Diversified Metal Fabricators Service Bulletin SB 2047:

Title	RW-1019 Washer Issue for 2005 and Newer Ford F-450/550's
Document No.	SB 2047
Issue Date	3/15/06 (WAK) Revised 4/24/06
Units Affected	Model year 2005 and newer Ford F-450s and F-550s
Purpose	This service bulletin addresses an installation error regarding RW-1019 front railgear on model year 2005 and newer Ford F-450's and F-550's.

Identify Units with Missing Pin Off Fender Washers

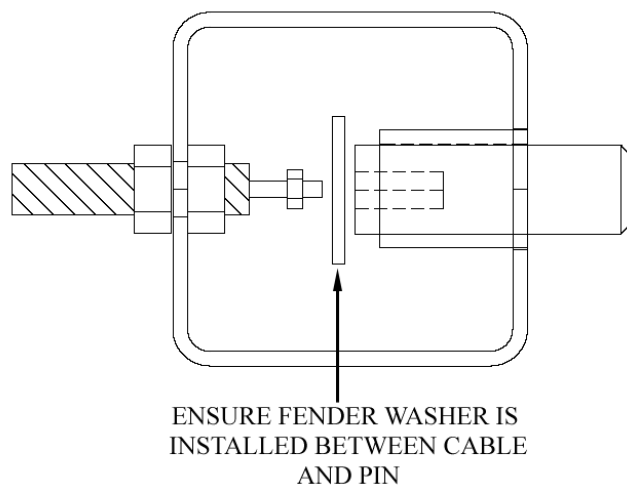
The illustration below shows the cable operated pin off assembly for RW-1019 railgear which is standard on models for 2005 and newer Ford F-450/550s. There should be a fender washer installed between the remote cable operator and the actual pin itself. The washer prevents the pin from being over inserted into the guide tube. Over insertion can allow the pin to become cockeyed in the guide tube and snap the pin-off cable where it threads into the pin.

If there is no washer, a new one must be installed.

Identify Units with Missing Washers

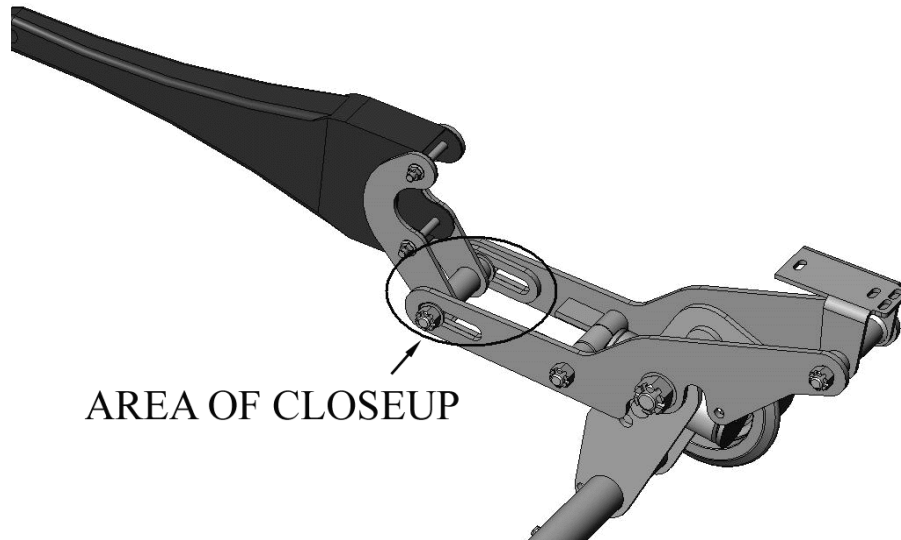
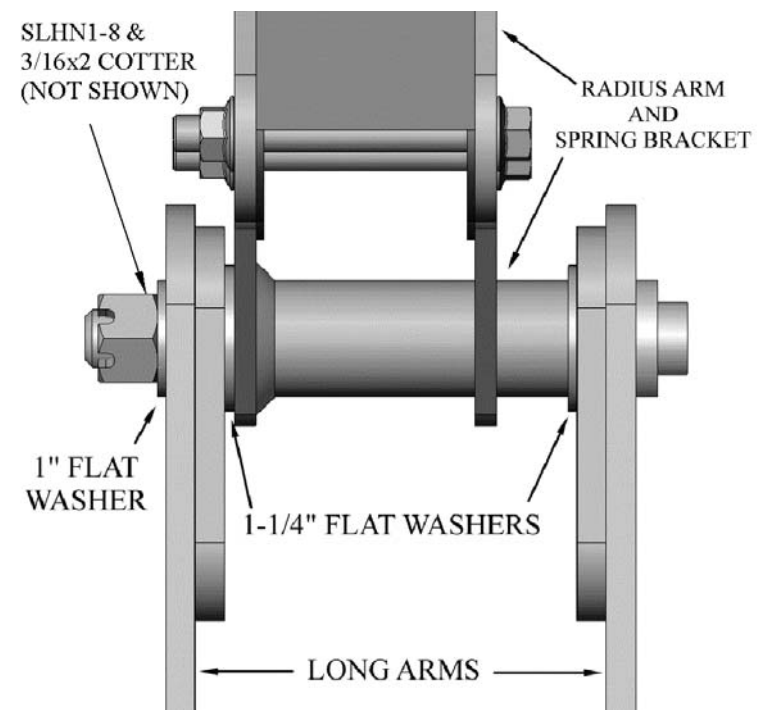
The picture below shows the driver's side of a front set of RW-1019 railgear for a 2005 model year Ford F-450/550. For each side of the truck there are supposed to be 3 washers for the rear pin. There is supposed to be a 1-1/4" washer between each long arm and the spring bracket bolted to the radius arm. Additionally there should be a 1" washer between the inner long arm and the castellated nut.

Please see the close-up diagram below for proper washer location.

Identifying excessively worn Long Arms

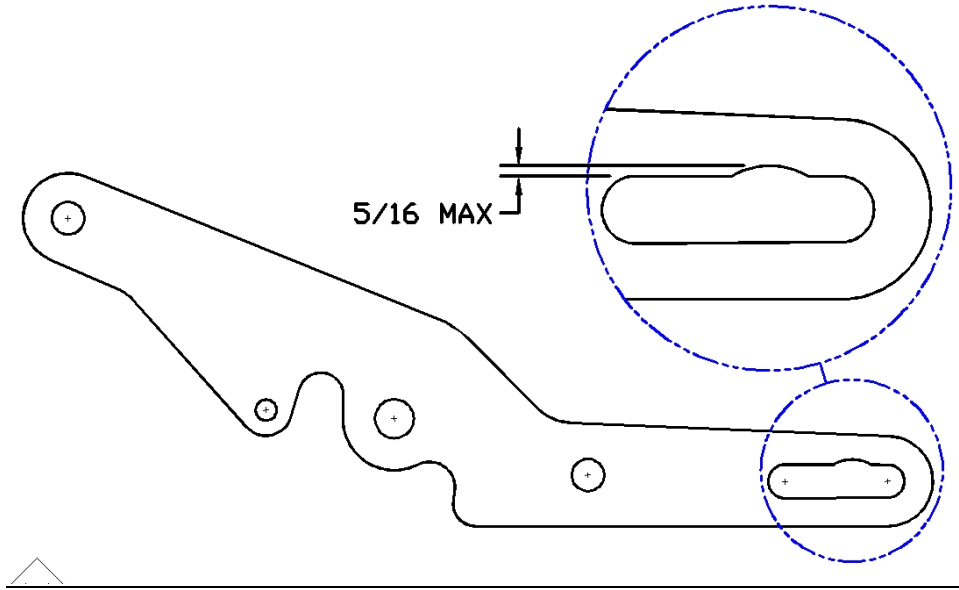
- Inspect slotted area of each long arm for excessive wear as shown above. Replace if necessary.
- Inspect 1" Slotted nut for excessive wear. Replace if necessary.
- Any unusual or excessive wear should be directed to DMF engineering for evaluation.
- All warranty claims must reference the railgear's serial number.
